CITY OF ALLENTOWN

R188 – 2022

Certificates of Appropriateness for work in the Historic Districts:

HDC-2022-00068**Address: 433 N. 11th Street****District: Old Allentown Historic District****Applicant: R. Joshua Weber, East Penn Roofing****Proposal: Replace slate roof with asphalt shingles****Building Description:**

Existing slate roof at 433 N. 11th Street, 2019.
(Google StreetView)

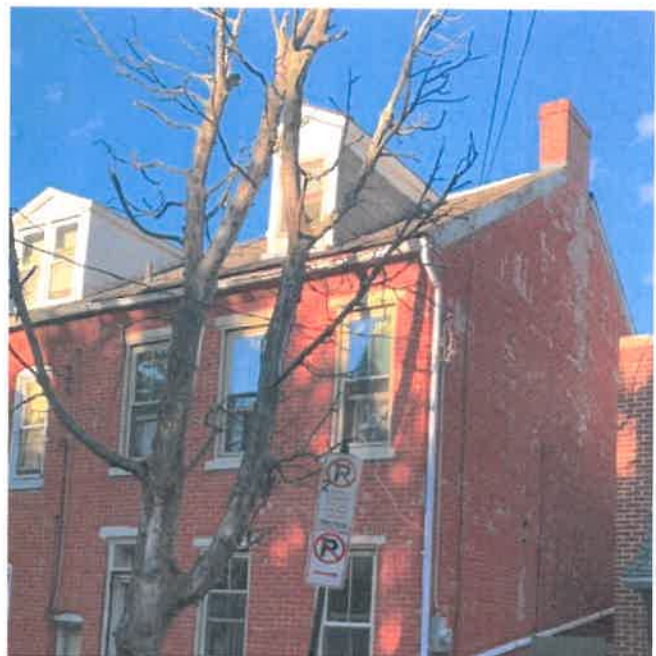
The applicant contends that the existing slate requires replacement because the slate is highly deteriorated. Staff notes that the condition photos show that several areas of slate are broken, missing, and displaced and the condition of the roof is generally poor. The applicant is proposing to install a dimensional asphalt shingle with exaggerated tapering that would differ in shape and color from the existing slate. The proposed shingles do not comply with Guideline 3.1.6. Staff recommends using a shingle that more closely replicates the existing slate in dimension, shape, profile, color, exposure, and overall appearance, such as GAF Slateline or a synthetic slate.

HARB Vice Chair AJ agreed with the staff recommendation and clarified he opposed the multi-colored, shake design proposed in the application.

AT, contractor present for the application requested leniency for cost reasons to allow use of 3-tab singles instead of Slateline series. GL asked if other manufacturers were researched for alternative, more cost-effective solutions. MK stated the HARB has previously approved the use of Atlas StormMaster Slate asphalt shingles to replicate slate which was cheaper than Slateline. AT agreed to look into using this alternative product.

Approval, pursuant to Chapter 3, Section 3.1 Roofs, provided that the new roofing material matches the historic slate in dimension, shape, profile, color, exposure, and overall appearance.

HARB Vice Chair AJ Jordan moved to approve w/conditions the application presented on *11/7/2022* for the roofing replacement at *433 N. 11th Street* with the following conditions agreed to by the applicant: the slate replacement material be of a type/manufacture previously approved by the HARB and must be submitted for staff review and approval in a color that replicates the original as closely as possible, and finds compliance with the following sections of the Guidelines for Historic Districts: Chapter 3, Section 3.1 Roofs, and finds that there are not circumstances unique to the property. HARB member Phillip Hart seconded the motion, which passed unanimously.

**933 W. Pine Street after exterior alterations.
(Applicant)**

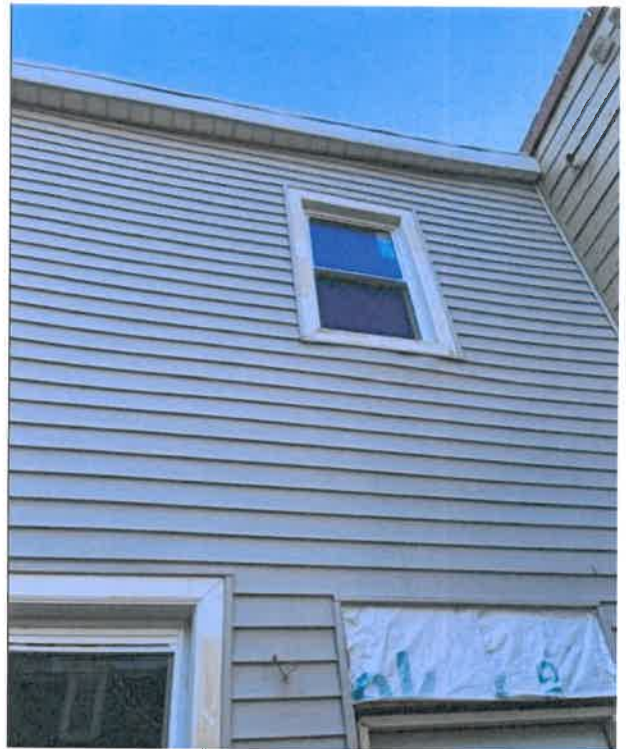
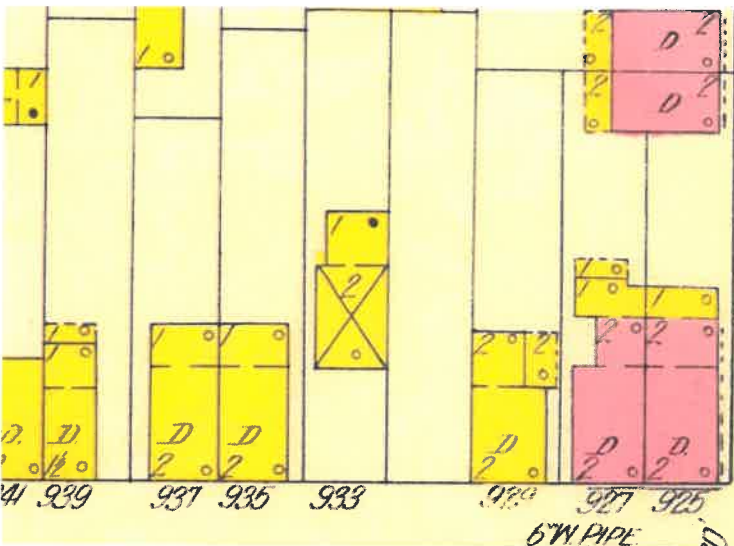
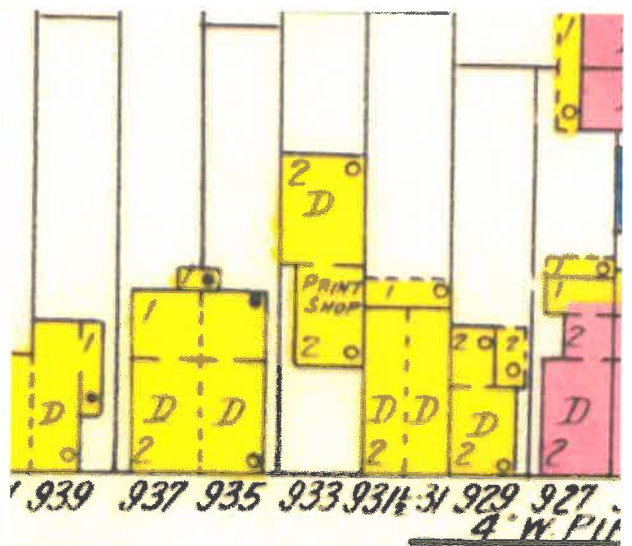
Staff questions whether the historic wood siding remains under the vinyl siding. The new cladding does not match the historic in material composition, size, profile, shape, pattern, or appearance and is not appropriate and does not comply

with Guidelines 3.2.5 and 3.2.6. The building historically had flush vertical boards. Staff recommends removing the vinyl siding and either exposing the original siding (if present) or installing new wood siding to match the historic.

Similarly, staff finds the second-story vinyl windows to be inappropriate in material composition, size, profile, appearance, and configuration. While the historic windows no longer remain, the age and function of the building suggest that the windows were likely wood six-over-six double-hung sash windows. Appropriate replacement windows should comply with Guideline 3.5.9. The photo prior to the exterior alterations shows that the windows did not have exterior trim, but did have a thin wood sill that should be replicated. The new vinyl windows do not comply with Guidelines 3.2.6 or 3.5.9.

Staff supports the applicant's proposal to remove the infill from the first-story opening and reinstall a garage door. Staff finds the proposed metal door imitating paneled wood to be inappropriate per Guideline 3.6.9 and recommends a wood door with a paneled design consistent with the wood paneled door that existed prior to the alteration. A crossbuck design would also be historically appropriate for the building's era of construction. Staff also recommends installing simple wood trim to match the historic garage opening. Removing the infill would return the historic fenestration patterns and would comply with Guidelines 3.5.10 and 3.5.11. However, the proposed garage door does not comply with design guidelines.

DH asked for clarification, MK clarified the area under consideration was on the primary façade of the building. The applicant wants to return the garage opening and legalize the vinyl windows and siding on the second floor. MK stated the structure was originally built as a garage or carriage house and is now attached to the adjacent building and should be reviewed as a standalone structure (reference the Sanborn Map).

Discussion of what the original material was once the vines and aluminum siding are removed and question of material integrity took place. Vice Chair AJ stated that there is no historic context to review the application in, recommending the HARB review the application in terms of scale, massing and density as reviewed for new construction since the original structure has been altered excessively as per section 3.11.10.

Denial of the legalization of the vinyl windows and siding, pursuant to Chapter 3, Section 3.2 Wood Siding & Trim and Section 3.5 Windows. Approval of the removal of the first-story infill and installation of a new garage door, provided the following:

- the infill is carefully removed so as not to damage the historic framing;
- new wood trim is installed to match the historic trim; and
- the new door is wood and is either paneled or contains a crossbuck design.

HARB Vice Chair AJ Jordan moved to approve the application presented on 11/7/2022 for the legalization of vinyl windows and siding and installation of a garage door to correct a violation at 933 W. Pine Street as submitted and find compliance with the following sections of the Guidelines for Historic Districts: Chapter 4, Additions to Existing Buildings, Section 4.1.4 finds that there are many unique circumstances to this property including a lack of historic context for the selection of alternative siding materials as well as the lack of historic context for this unique structure as it was built originally to be unique to the neighborhood street wall and context. HARB member Glenn Lichtenwalner seconded the motion, which passed 4-1, HARB Chair Dave Huber dissented.

**933 W. Pine Street after exterior alterations.
(Applicant)**

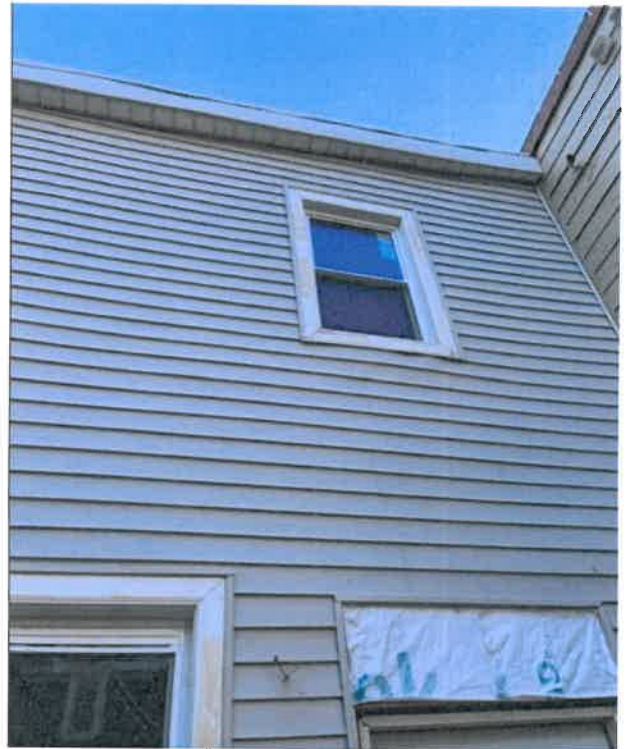
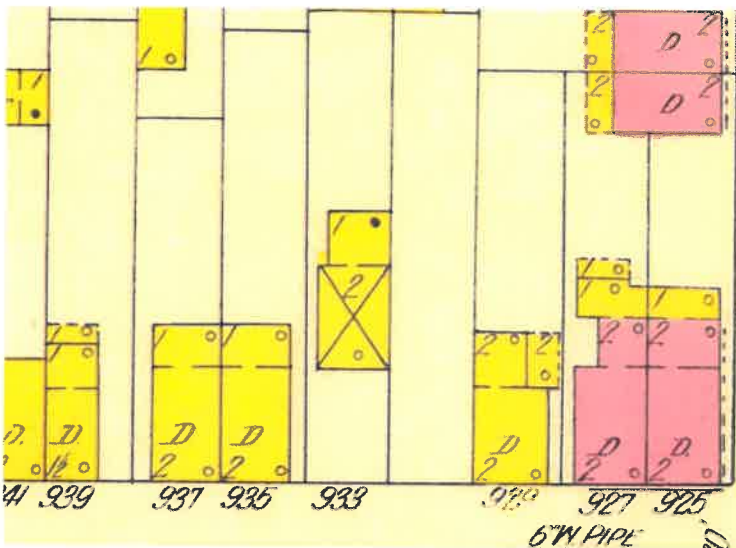
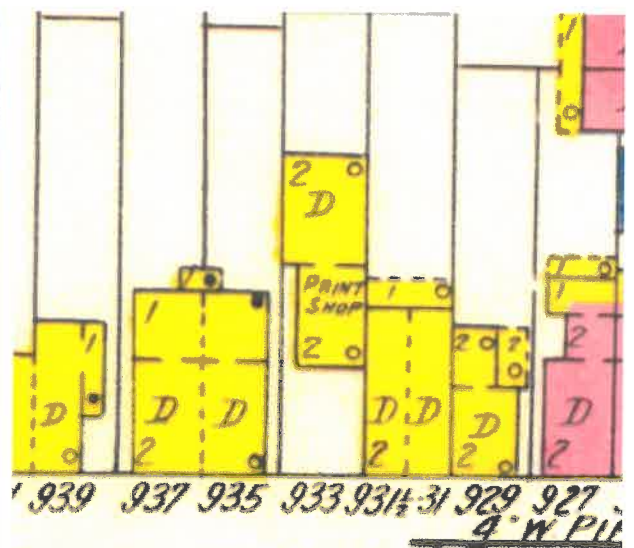
Staff questions whether the historic wood siding remains under the vinyl siding. The new cladding does not match the historic in material composition, size, profile, shape, pattern, or appearance and is not appropriate and does not comply

with Guidelines 3.2.5 and 3.2.6. The building historically had flush vertical boards. Staff recommends removing the vinyl siding and either exposing the original siding (if present) or installing new wood siding to match the historic.

Similarly, staff finds the second-story vinyl windows to be inappropriate in material composition, size, profile, appearance, and configuration. While the historic windows no longer remain, the age and function of the building suggest that the windows were likely wood six-over-six double-hung sash windows. Appropriate replacement windows should comply with Guideline 3.5.9. The photo prior to the exterior alterations shows that the windows did not have exterior trim, but did have a thin wood sill that should be replicated. The new vinyl windows do not comply with Guidelines 3.2.6 or 3.5.9.

Staff supports the applicant's proposal to remove the infill from the first-story opening and reinstall a garage door. Staff finds the proposed metal door imitating paneled wood to be inappropriate per Guideline 3.6.9 and recommends a wood door with a paneled design consistent with the wood paneled door that existed prior to the alteration. A crossbuck design would also be historically appropriate for the building's era of construction. Staff also recommends installing simple wood trim to match the historic garage opening. Removing the infill would return the historic fenestration patterns and would comply with Guidelines 3.5.10 and 3.5.11. However, the proposed garage door does not comply with design guidelines.

DH asked for clarification, MK clarified the area under consideration was on the primary façade of the building. The applicant wants to return the garage opening and legalize the vinyl windows and siding on the second floor. MK stated the structure was originally built as a garage or carriage house and is now attached to the adjacent building and should be reviewed as a standalone structure (reference the Sanborn Map).

Discussion of what the original material was once the vines and aluminum siding are removed and question of material integrity took place. Vice Chair AJ stated that there is no historic context to review the application in, recommending the HARB review the application in terms of scale, massing and density as reviewed for new construction since the original structure has been altered excessively as per section 3.11.10.

Denial of the legalization of the vinyl windows and siding, pursuant to Chapter 3, Section 3.2 Wood Siding & Trim and Section 3.5 Windows. Approval of the removal of the first-story infill and installation of a new garage door, provided the following:

- the infill is carefully removed so as not to damage the historic framing;
- new wood trim is installed to match the historic trim; and
- the new door is wood and is either paneled or contains a crossbuck design.

HARB Vice Chair AJ Jordan moved to approve the application presented on *11/7/2022* for the legalization of vinyl windows and siding and installation of a garage door to correct a violation at *933 W. Pine Street* as submitted and find compliance with the following sections of the Guidelines for Historic Districts: Chapter 4, Additions to Existing Buildings, Section 4.1.4 finds that there are many unique circumstances to this property including a lack of historic context for the selection of alternative siding materials as well as the lack of historic context for this unique structure as it was built originally to be unique to the neighborhood street wall and context. HARB member Glenn Lichtenwalner seconded the motion, which passed 4-1, HARB Chair Dave Huber dissented.
